# Value Engineering Study

Final Report

## Hal Rogers Parkway KY 30 to KY 192 (MP 1.089 to MP 3.877) Laurel County Item No. 11-365.00

May 25, 2022

SKETCH/DIAGRAM: Existing Alignment vs. Baseline Concept (Two-Lane vs Four-Lane)

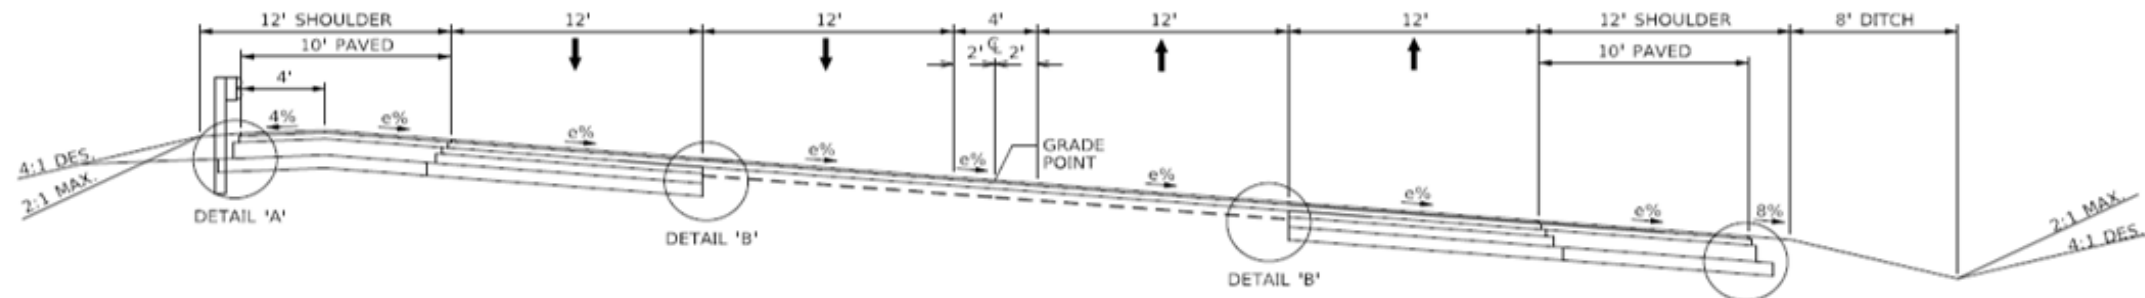
<b>VE PROPOSAL DESCRIPTION:</b>			
Utilize the existing two-lane alignment along the corridor. Construct focused intersection improvements at each intersection (specific intersection recommendations are detailed in subsequent pages).			
<b>ADVANTAGES:</b>		<b>DISADVANTAGES:</b>	
● Reduces congestion		● Travel time through the two lane corridor is longer with reduced opportunities to pass	
● Improves safety		● The corridor level of service (LOS) is a "C" with two lanes roads, which is lower than a five lane typical LOS	
● Under budget of the Six-Year Plan construction funding		●	
● Intersection improvements could potentially reduce Fatal and Serious Crashes by 50%		●	
● Eliminates need to replace Slate Lick Road Bridge		●	
● Shorter construction duration and MOT		●	
● Reduces future resurfacing costs (two lanes versus four lanes and median width)		●	
<b>Overall Performance Score</b>			<b>5.3</b>
<b>\$ COST SUMMARY</b>	<b>Initial Costs</b>	<b>O&amp;M Costs</b>	<b>Total Life Cycle Cost</b>

<b>TITLE</b>	Existing alignment with intersection improvements
<b>DISCUSSION &amp; JUSTIFICATION:</b>	
<p>The preliminary cost estimate for the baseline concept was approximately \$17.3 million, which is above the \$9 million designated for construction in the Six-Year Plan. By using the existing two-lane roadway, focused improvements at each intersection from KY 30 to KY 192 may be implemented that are under budget. These improvements at the intersections would reduce congestion, along with reducing crashes, and satisfy the purpose and need for this project.</p> <p>Over a five-year crash history, this corridor (from the High School to KY 192) had 154 total crashes with 31 crashes being injury related collisions. 131 crashes (85% of total crashes) occur at an intersection with 29 (93% of injury crashes) of those crashes being injury related collisions. The intersection of Hal Rogers at KY 30 had 59 total crashes with 16 crashes being injury related collisions.</p> <p>This portion of Hal Rogers Parkway experiences AADT ranging from 11,882 to 10,299 with 11.98 percent trucks. Using Traffic Count Station data (AADT, K-Value, and Directional Splits), a planning level design hour was calculated. The VE team used background information provided and engineering judgment to estimate the turning movement percentages that resulted in hourly turning movement volumes. The school system also provided traffic counts for school buses, parent drop-off and pick-up, staff, and student drivers. This information was used to aid in the turning movement calculation at the High School intersection and KY 472 – Middle School intersection.</p> <p>The existing two-lane roadway was analyzed using Highway Capacity Software and the associated calculated peak hour volumes. The Demand/Capacity ratio is 0.41 for the two-lane segments with a Free-Flow Speed of 61.1 mi/h. Passing zones are permitted in the tangent sections and between intersections and results in an average speed of 58.3 mi/hr with 6.4 Follower Density (followers/mi/ln). The existing two-lane HCS analysis resulted in LOS C.</p>

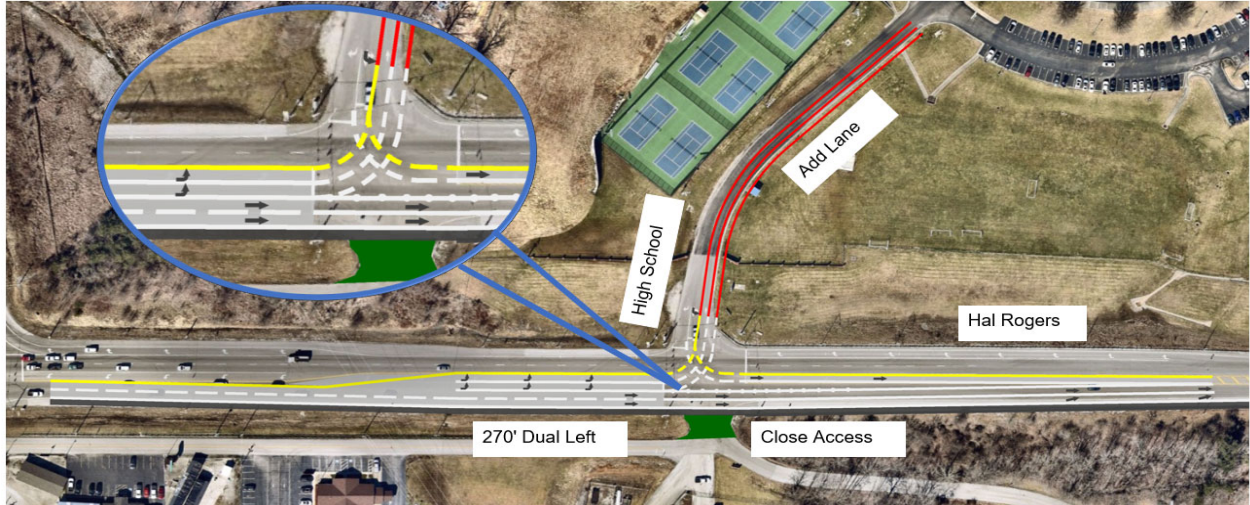
Based on the analysis, the VE Team made the following recommendations: Hal Rogers EB Dual Left and Continuous Greet T (CGT) as illustrated below.

SKETCH/DIAGRAM: BASELINE CONCEPT

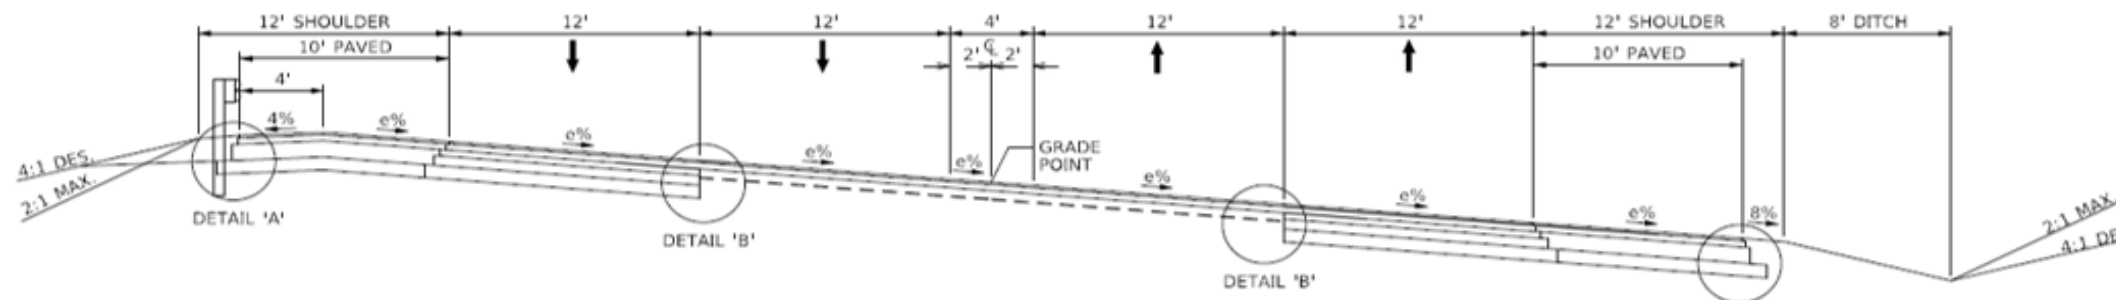
<b>TITLE</b>	Baseline concept with intersection improvements		
<b>FUNCTION</b>	<b>Miscellaneous</b>		
<b>VALUE PROPOSAL SYNOPSIS:</b>			
Utilize the baseline alignment with focused improvements at the intersections. The congestion and safety related areas of improvement along this project occur at the intersections. Investment of the available funding needs to address the congestion and safety concerns at the intersections.			
 <b>Reliability</b>	Maintained	 <b>Functionality</b>	Improved
 <b>O&amp;M</b>	Improved	 <b>Schedule Impact</b>	Maintained
			<b>\$ Initial Cost Avoidance (Add)</b>
			<b>(\$1,335,000)</b>
<b>BASELINE CONCEPT:</b>			
Pavement widening along the corridor to widen the existing typical to a four-lane undivided typical section. Improvements at the intersections include construction of innovative intersections, turn lane extensions, and signal timing adjustments.			
<b>VE PROPOSAL DESCRIPTION:</b>

<b>TITLE</b>	Baseline concept with intersection improvements
<b>DISCUSSION &amp; JUSTIFICATION:</b>	
<p>The baseline concept for this corridor is focused around widening the pavement to provide a four-lane typical section. Minor improvements that include extending turn lanes and signal modifications are proposed at intersections. Since 131 crashes (85% of total crashes) occur at an intersection with 29 (93% of injury crashes) of those crashes being injury related collisions, the VE Team recommended focused improvements at each intersection. Before we look at the intersection improvements, below is a traffic and safety summary of the four-lane segments.</p>	
<p>This portion of Hal Rogers Parkway experiences AADT ranging from 11,882 to 10,299 with 11.98 percent trucks. Using Traffic Count Station data (AADT, K-Value, and Directional Splits), a planning level design hour was calculated. The VE Team used background information provided and engineering judgment to estimate the turning movement percentages that resulted in hourly turning movement volumes. The school system also provided traffic counts for school buses, parent drop-off and pick-up, staff, and student drivers. This information was used to aid in the turning movement calculation at the High School intersection and KY 472 – Middle School intersection.</p>

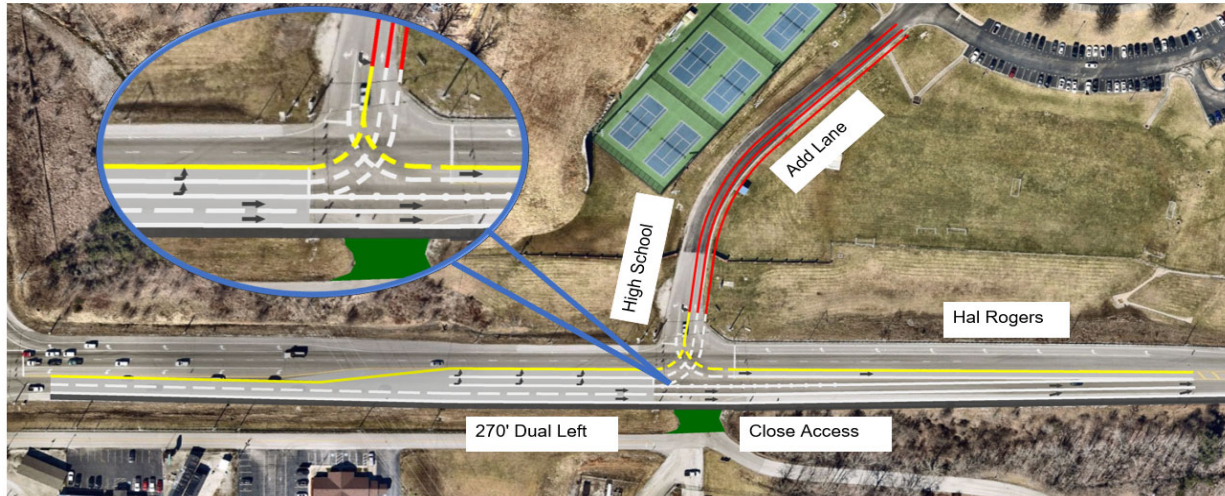
Based on the analysis, the VE Team made the following recommendations: Continuous Green T (CGT) as illustrated below.

SKETCH/DIAGRAM: VE PROPOSAL

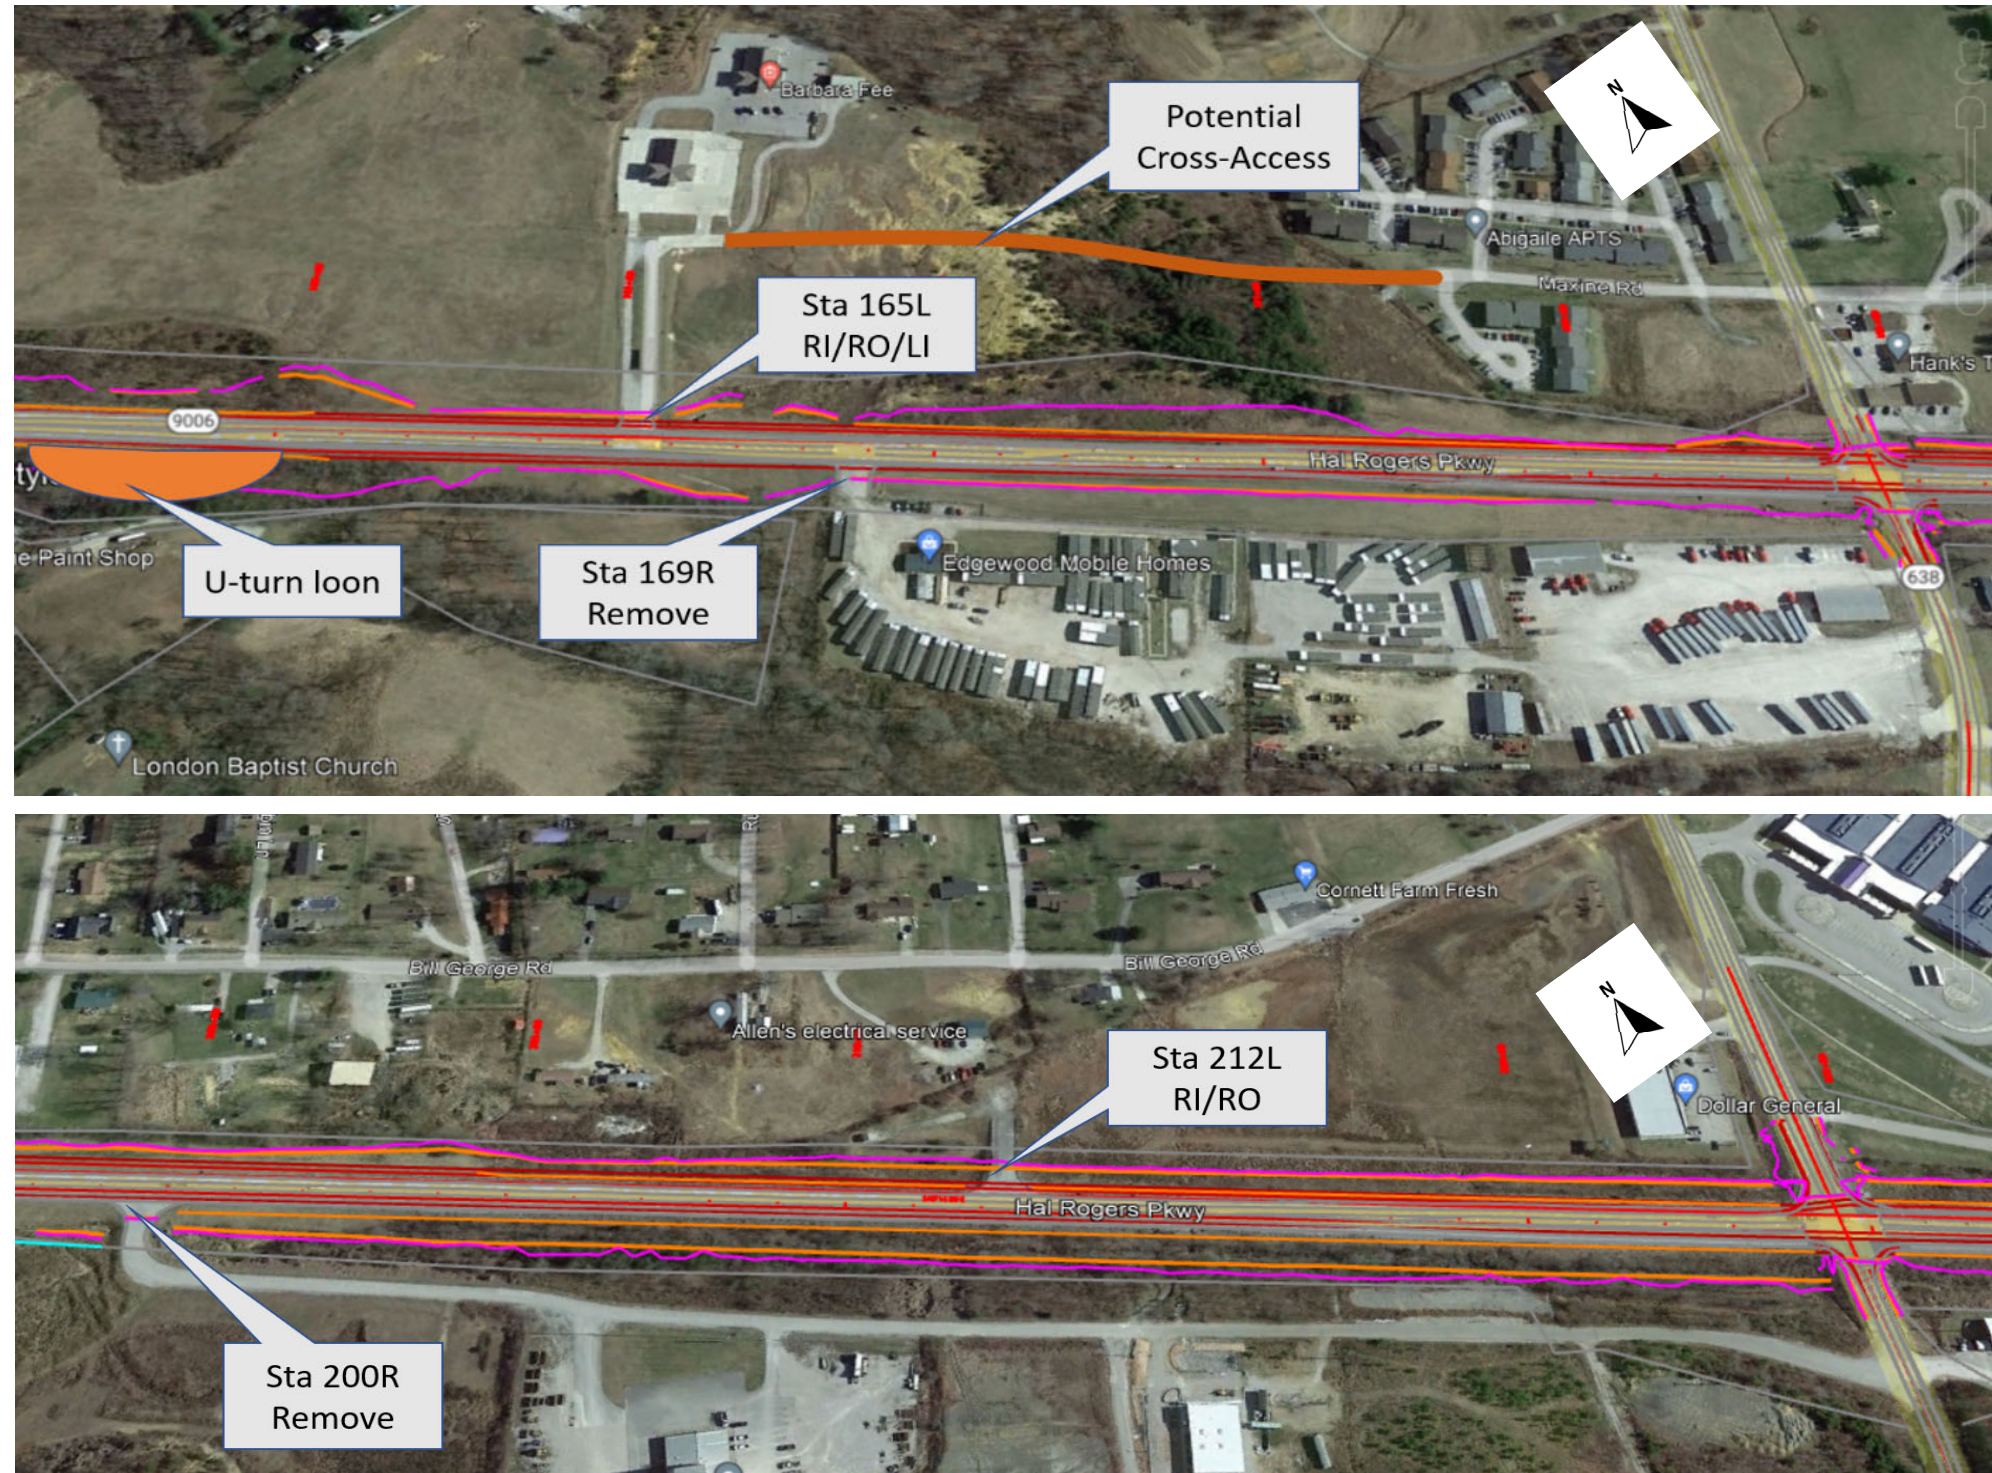
<b>TITLE</b>	Provide access management strategies at non-signalized approaches		
<b>FUNCTION</b>	<b>Increase Capacity (Improve traffic flow, reduce delay)</b>		
<b>VALUE PROPOSAL SYNOPSIS:</b>			
As the Hal Rogers Parkway evolves, it should do so in a way that minimizes the amount of direct access to the roadway in order to maximize safety and traffic flow efficiency. All unnecessary access should be removed and necessary access should have limited turning movements.			
 <b>Reliability</b>	Maintained	 <b>Functionality</b>	Improved
 <b>O&amp;M</b>	Maintained	 <b>Schedule Impact</b>	Maintained
			<b>\$ Initial Cost Avoidance (Add)</b>
			<b>(\$50,000)</b>
<b>BASELINE CONCEPT:</b>			
The current design leaves each existing access point with no restrictions on turning movements.			
<b>VE PROPOSAL DESCRIPTION:</b>			
For each uncontrolled access, restrict exiting movements to a right-in and right-out or close the access where alternative access can be provided. Do not allow additional access in the future to this section of the mainline.

Recommended modifications to unsignalized access locations

<b>TITLE</b>	Provide access management strategies at non-signalized approaches
<b>DISCUSSION &amp; JUSTIFICATION:</b>	
<p>As the Hal Rogers Parkway evolves, it should do so in a way that minimizes the amount of direct access to the roadway in order to maximize safety and traffic flow efficiency. All unnecessary access should be removed and necessary access should have limited turning movements.</p>	
<p>There are currently four locations that should have modifications to the existing access (see diagram). It is important to make changes so as to set the precedent that no additional full access is given in the future.</p>	
<p>Two of the locations should fully close the access. At each, there is a secondary existing access to a cross street. Note that there are two crashes from the given crash data associated with the entrance at Station 169.</p>	
<p>The other two locations should have the turning movements restricted so no traffic from the property can turn left or go straight across. For the location at approximately Station 165, it is recommended that a loon be built on the parkway to the west of the intersection. This will accommodate drivers to make the left-turn movement indirectly - would turn right from the entrance and then do a U-turn at the loon. This design enhancement will be critical as the intensity of land use at this location is currently planned to intensify with additional development. There were two crashes (1 injury) at the access at station 165; without this design change, the number of crashes would be expected to increase with increased traffic to and from this property.</p>

**SKETCH/DIAGRAM: VE PROPOSAL**

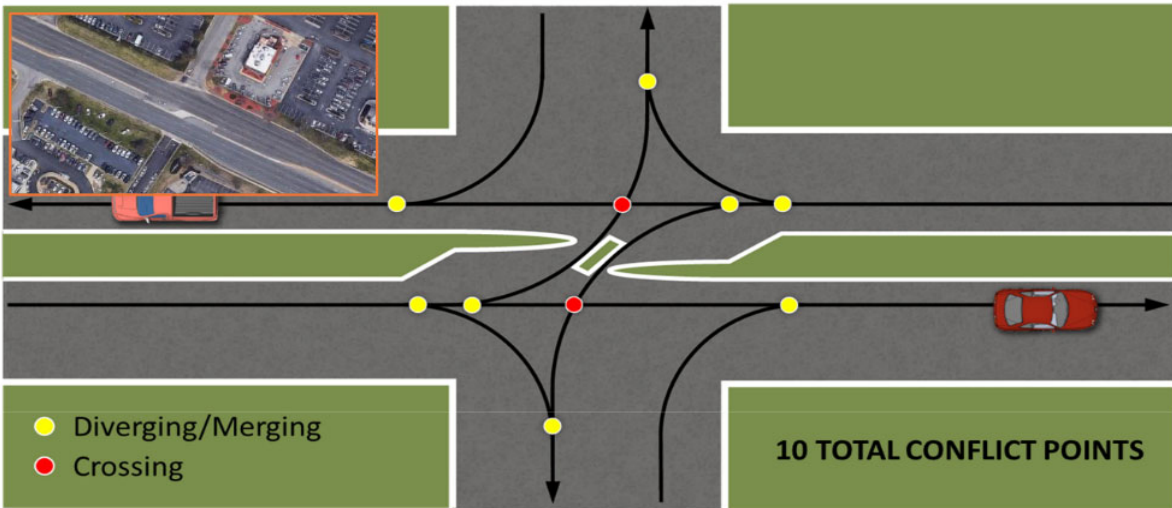
**Directional median opening allows right-in, right-out, and left-in movements only**
